Subject: Docket No. 50-482: Response to Request for Additional Information Relating to Replacement of the Main Steam and Feedwater Isolation Valves and Controls

**Westinghouse Electric Company LLC LTR-LIS-07-898 NP-Attachment, "Response to
Second Round NRC Request for Additional Information on the Wolf Creek Small Break
LOCA Analysis"
(NON-PROPRIETARY)**

Response to Second Round NRC Request for Additional Information on the Wolf
Creek Small Break LOCA Analysis

Figure 2-1: Wolf Creek Unit 1 ECCS Diagram

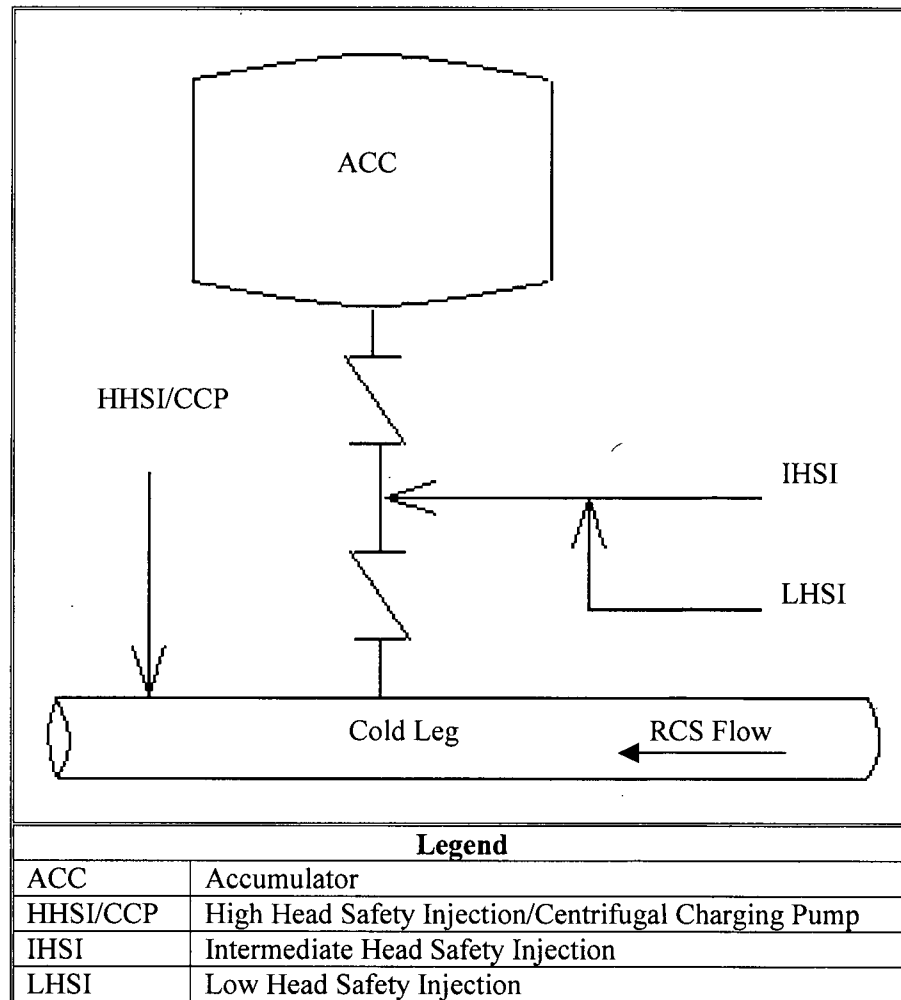
The response to Question 9 states that the high pressure safety injection (HPSI) line is attached directly to the cold leg. As such, address the following: (1) does a severed HPSI line with degraded HPSI flow cause PCT to become more limiting before the accumulators inject, (2) is there a break size on the RCS side of the break that delays accumulator and low pressure safety injection (LPSI) so only the degraded HPSI flow into the RCS occurs causing a more limiting PCT, and are the centrifugal charging pumps (CCPs) qualified for LOCA and actuated on the safety injection actuation signal (SIAS)?

A diagram of the WCGS ECCS is provided below in Figure 2-1.

As stated in the Round 1 RAI 9 response, the 8.75-inch equivalent diameter break modeled a severed accumulator line. Although realistically the HHSI would still inject to the broken loop cold leg, this scenario modeled all safety injection to the broken loop (Accumulator, HHSI/CCP, IHSI, and LHSI) to spill to containment pressure. For this case, there is only minimal core uncover for a short duration. Furthermore, the core exit vapor temperature drops quickly to ~400°F and then steadily decreases to ~300°F over the remainder of the transient. Table 2-1 below summarizes the time sequence of events for
